**Re: Ontario Power Generation Inc.  
Board File No. EB-2013-0321**

**Board Staff Interrogatories  
Ontario Power Generation Inc. ("OPG")  
2014-2015 Payment Amounts  
EB-2013-0321  
February 21, 2014**

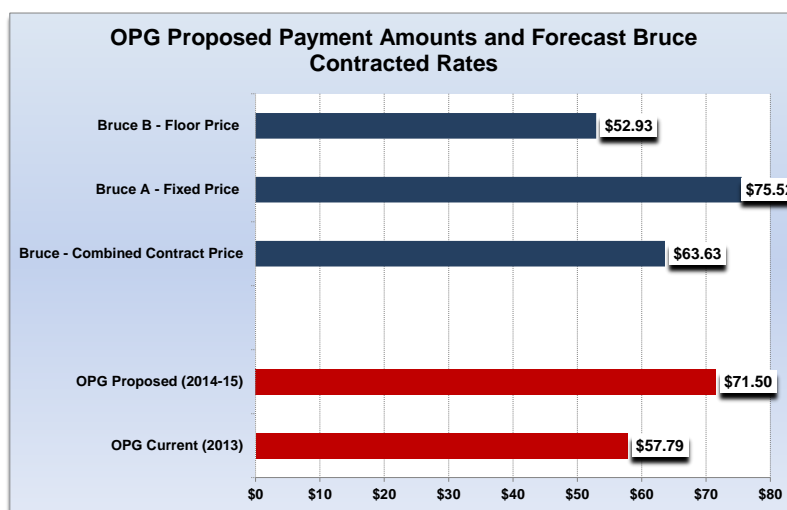
On February 6, 2014, OPG updated its evidence, including the Business Case Summary ("BCS") for project 10-800014 Fuel Life Extension Project (F2-3-3 Attachment 1 Tab 11).

- a) Please describe how this project is separate from project 10-62444 Fuel Life Channel Management. Is this new extension project contingent on the work done on or the outcomes of the earlier project?
- b) Please confirm that the costs for the Fuel Life Channel Management and Fuel Life Extension projects are entirely separate.

- c) Please update F2-3-3 Table 1 OM&A Project Listing – Nuclear Projects ≥ \$20M Total Project Cost to include project 10-800014 Fuel Life Extension Project. Also, please insert a column between 2013 Budget and 2014 Plan and show 2013 actuals (audited or unaudited) for each project.
- d) Please update F2-3-3 Table 5 to include project 10-800014 Fuel Life Extension Project.

Ref: Exh F4-4-1 Table 1

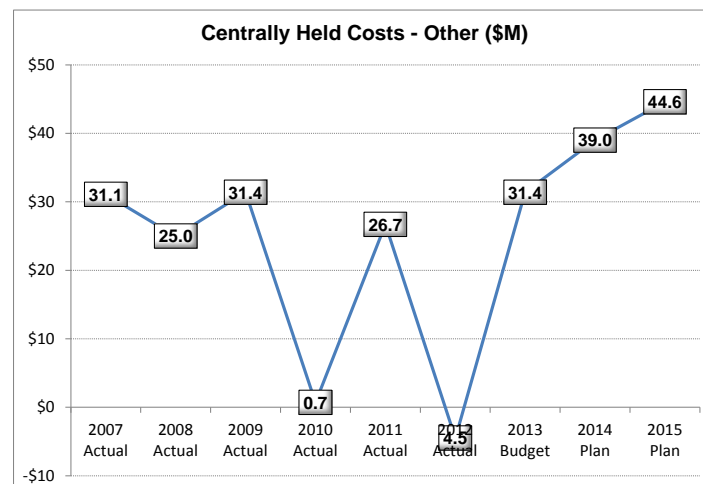
The chart below is related to the “Other” category of Centrally Held Costs. The chart includes actual costs from the previous application (2007 – 2009) as well as the actual and proposed costs from the current application. There is a consistent trend of alternating increases and decreases each year. The actual costs also consistently peak at just over \$31 million until the bridge year. However, in the test years, there is a deviation from both of those trends. First, instead of alternating increases and decreases, it increases in both of the test years following an increase in 2013 (i.e., 3 straight years of increases). Second, the proposed increase is substantially higher – about \$13 million – than the amount it has consistently peaked at.

- Please explain the deviation from the two trends noted above.
- Please also provide a table that provides a breakdown of all the different types of costs and associated amounts that are included in the “Other” category for each of the years in the current application (2010-2015).
